# LED Replacement Light Source

## - open items 2020-05

# LED Replacement Light Source (LEDr) acc. to R37

# Failure detection system compatibility (non-DI) – two options

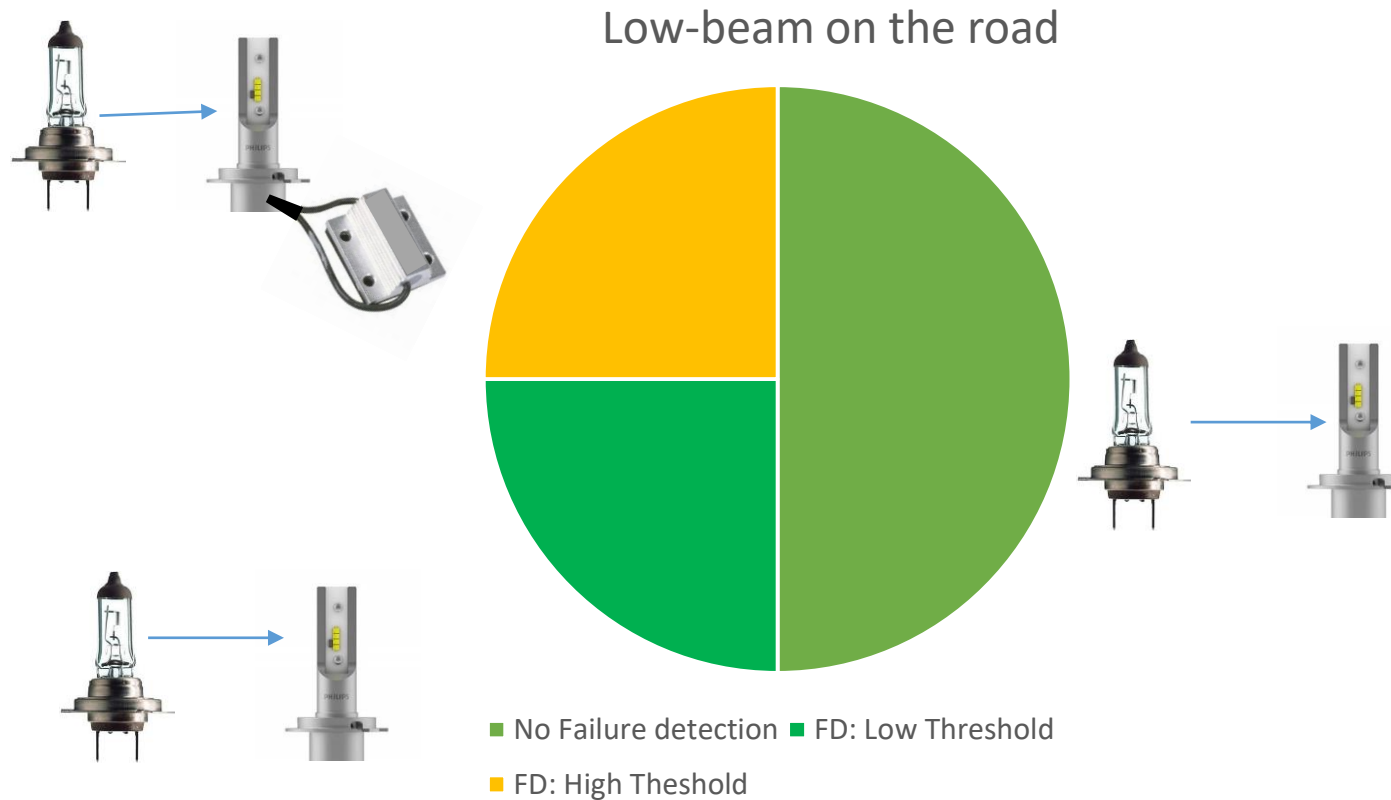
## Solution B- only a “high power” version

- Increase of electronic waste by adding additional components where they are not necessary
- Artificially increased power consumption where low power consumption could be enabled

-> increased CO2 emissions, increased waste

# Option B: One versions

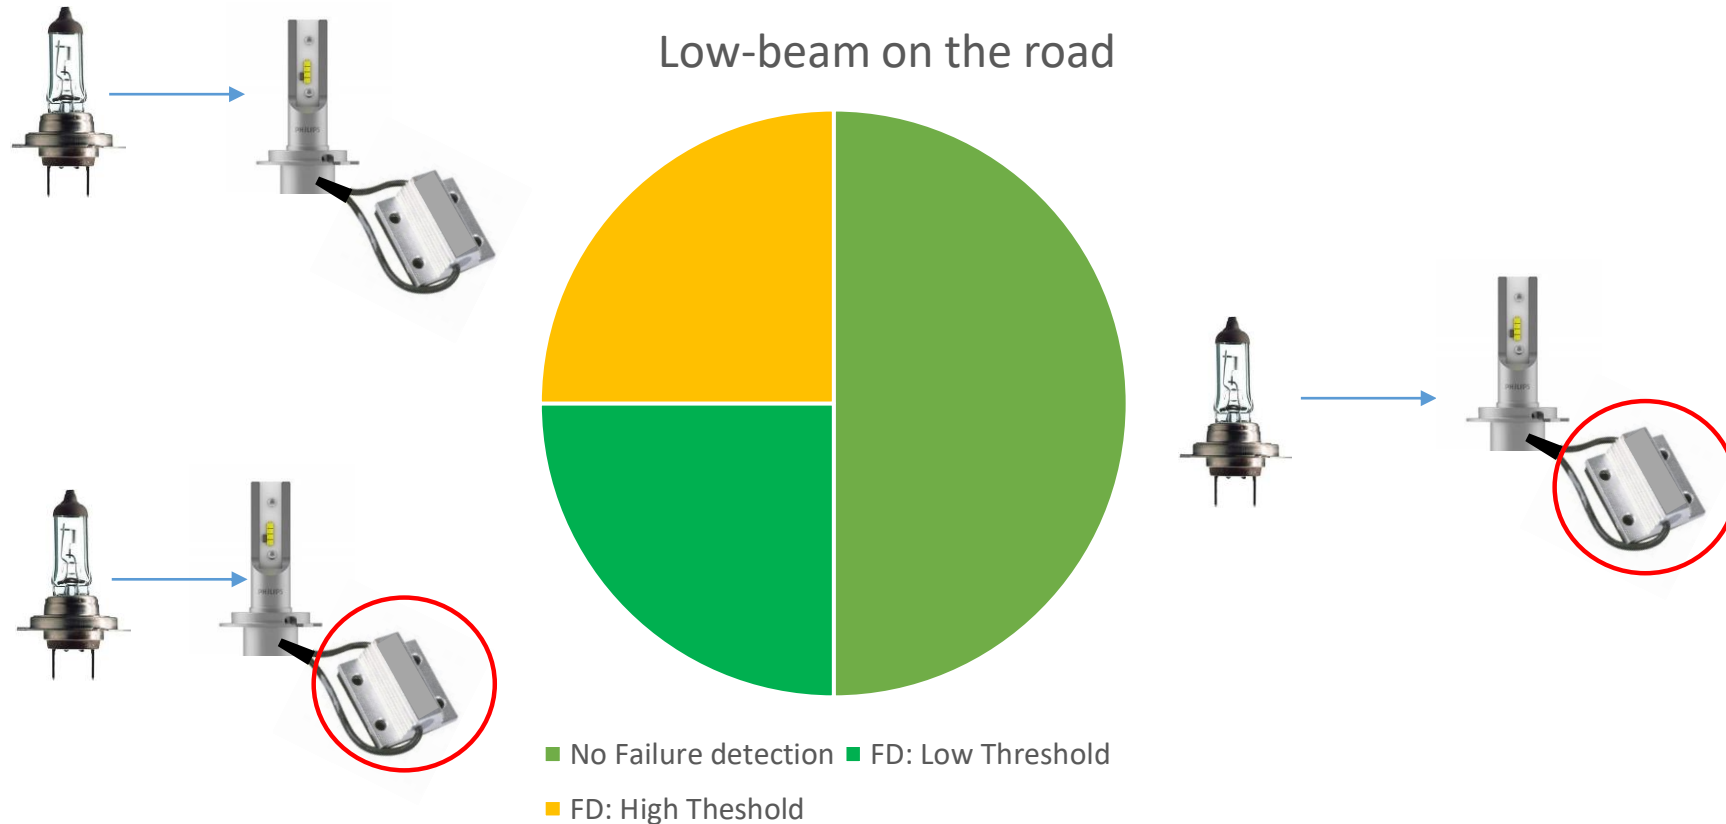
- unnecessary “**electronic waste**” (in total: 3 times more waste)
- Artificially **increased energy** consumption (in total: 60% more energy / CO2)
- No consumer information needed

### - High ambient temperature

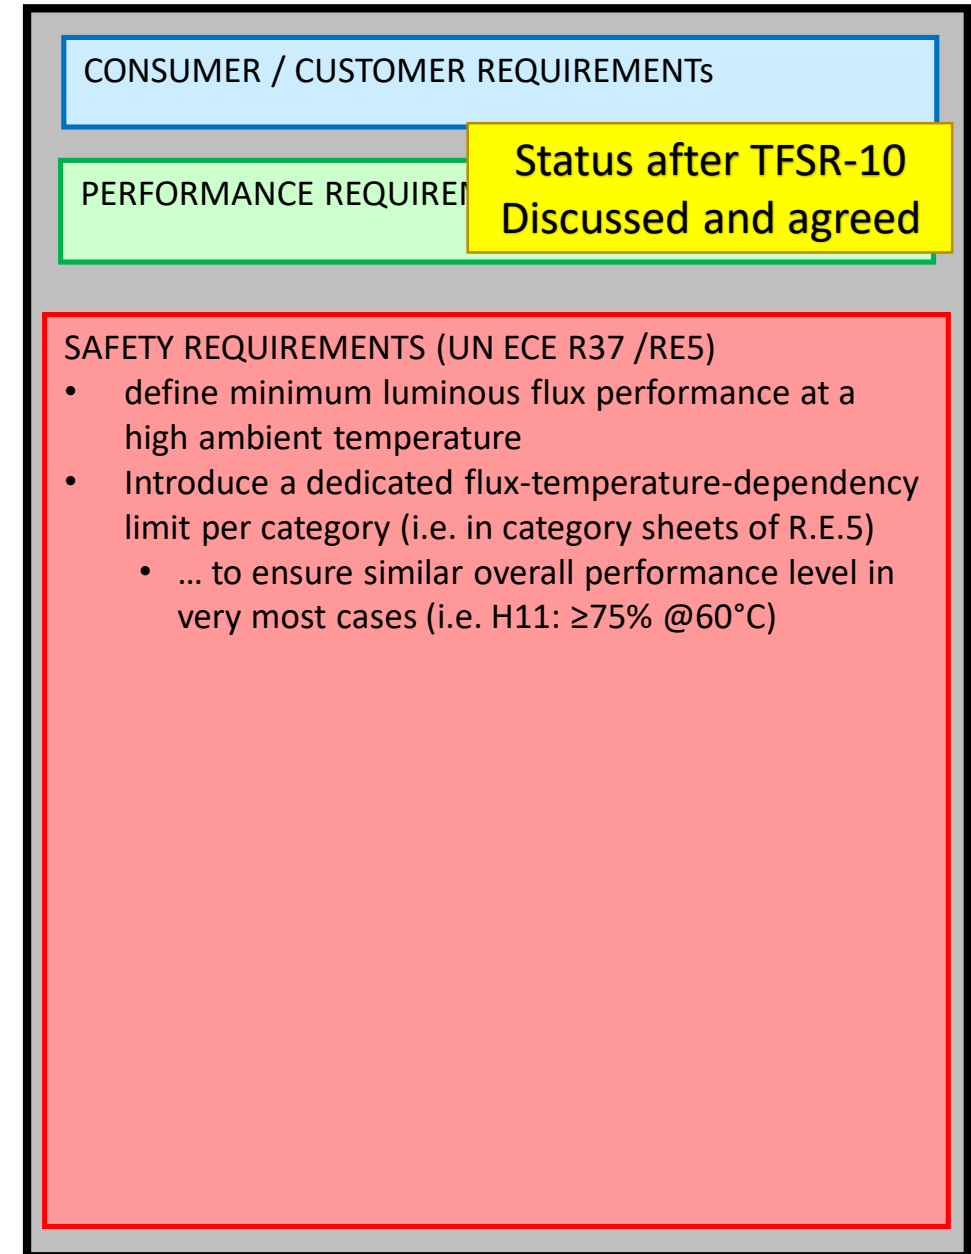
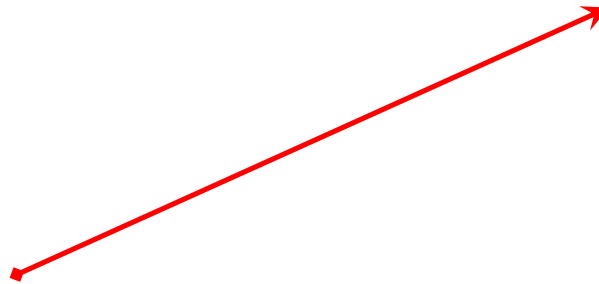
Could it happen that the LEDr has significantly reduced intensity when it is operated at high ambient temperature?

LED-technology has a temperature-dependent behaviour. Additional tests are defined to ensure that there is no significant reduction of luminous flux.

The “real-world” temperatures show a function-, vehicle- and climate-specific statistical distribution.

Status after TFSR-10  
Discussed and agreed

# INFO #2: Thermal situation of headlamps

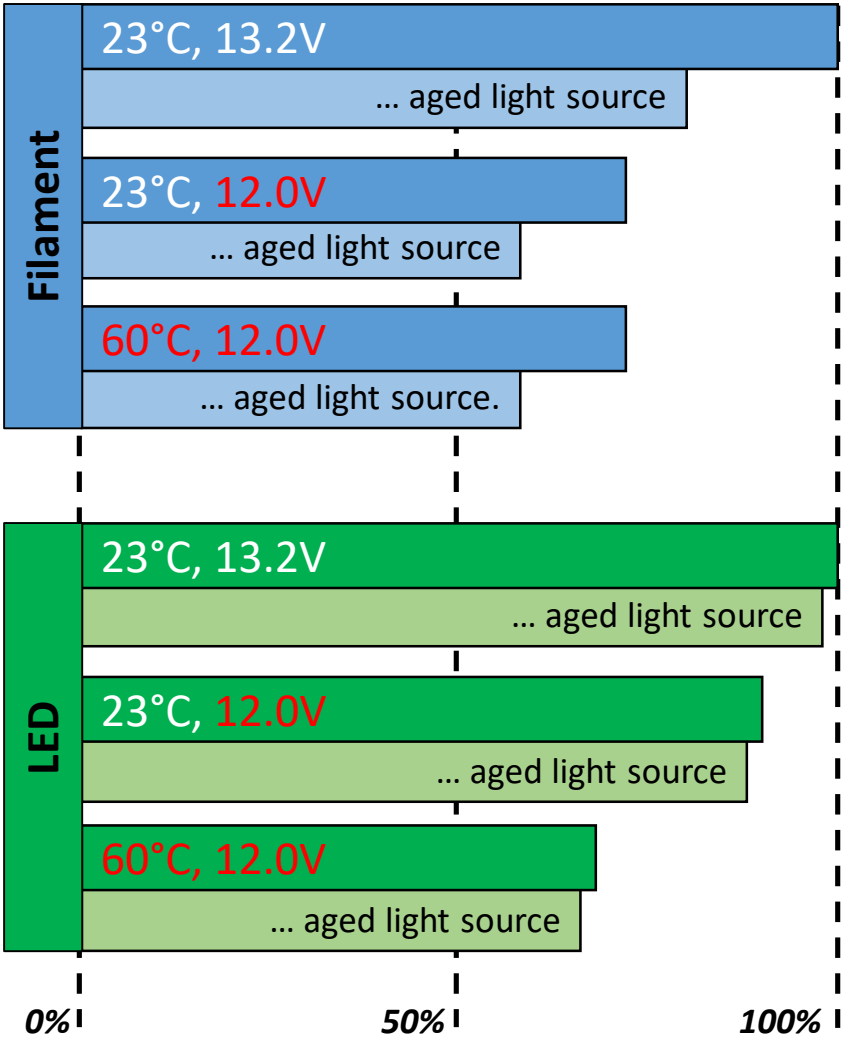
➤ Assumption: 1/3 of housing is exposed to the “outside air”  $T_{out}$  and 2/3 to the engine compartment  $T_{sp}$  (i.e. impact of the engine side weighted by factor 2)

$$T_{test} \approx \frac{2}{3} \cdot T_{sp} + \frac{1}{3} \cdot T_{out}$$

TFSR-10: Could be simplified to:  
60°C → 75% flux

$T_{sp}$	Distribution	$T_{test}$	Proposed testing	Proposed criteria (e.g. H11)
-40°C	6%			
23°C	20%	~20°C *	Regular test (@23°C) after 30min	1350 lm ± 10%
65°C	65%	~48°C *	Additional test @50°C after 30min	≥80% of value @23°C
115°C	8%	~82°C *	Additional test @80°C after 30min	≥60% of value @23°C
120°C	1%	~85°C *

# Cap temperature: *technical background*

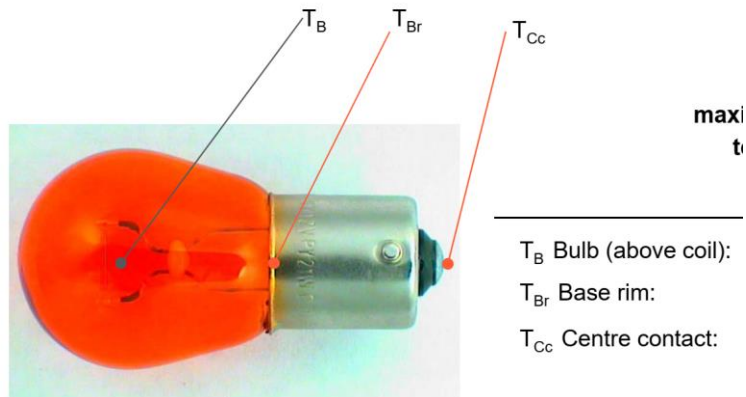
- Energy balance different between filament and LED technology
- Avoid thermal overload of holder made for filament light source
- Use typical filament cap temperature as safe reference

Maximum at  $T_{Br}$ : 90 °C @23°C ambient, 13.5V, flashing

## Measurement point:

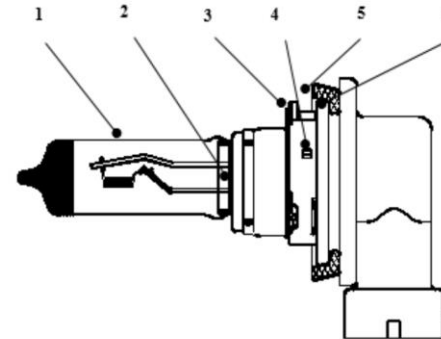
MP1: bulb above the filament  
MP2: pinch at the flap  
MP3: reference lug  
MP4: reference diameter  
MP5: sealing ring above  
MP6: cap

Maximum for MP4:  
150 °C @23°C ambient, 13.2V
